ADDENDUM NO. 1

DATE: May 25, 2022
FROM: City of Grand Junction Purchasing Division
TO: All Interested Parties
RE: Water Treatment Plant Electrical Improvements IFB-5074-22-SH

Diagram for Question 2

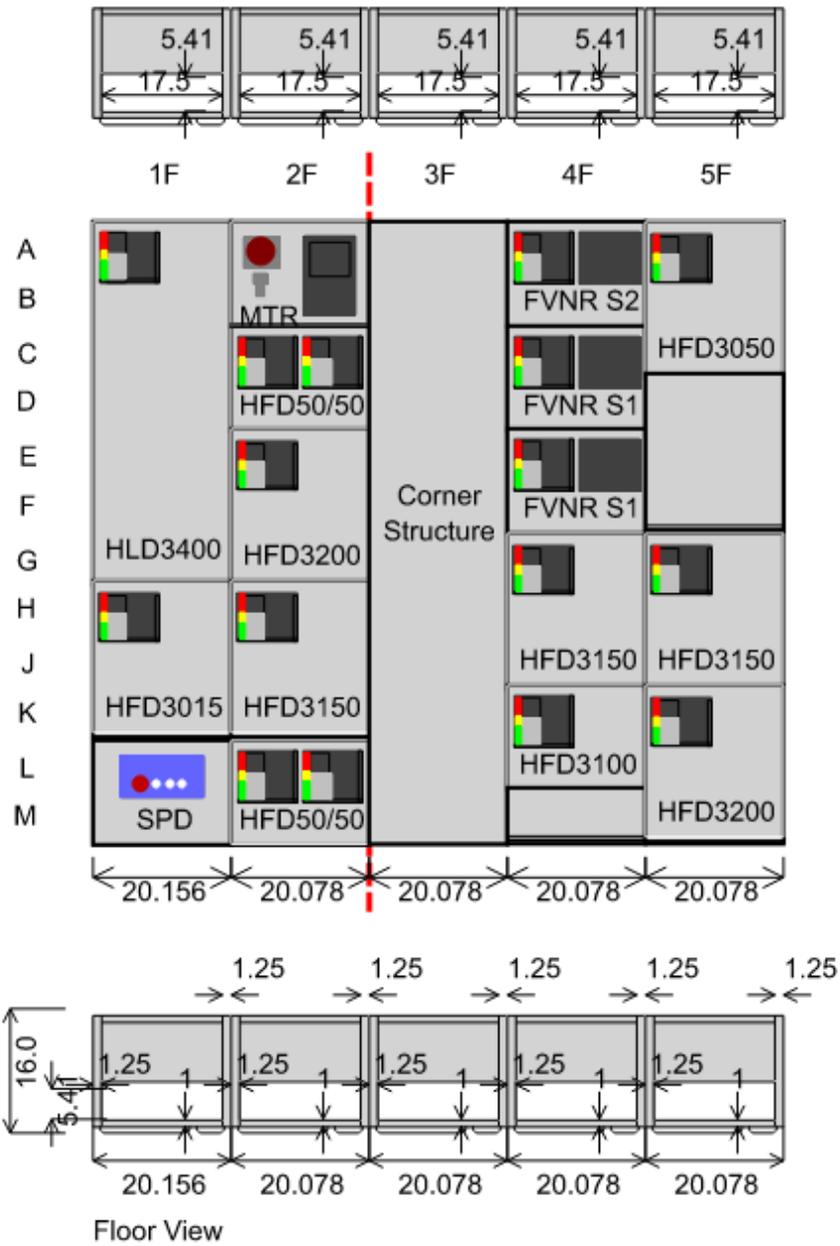
Question 2. The one-line on page 101 shows what devices to have in the MCC but the Engineer did not provide an elevation drawing. This will need to be specified in order to in the existing space that is shown in the picture on the contract drawings provided.

Answer: Please see diagram attached to this Addendum.
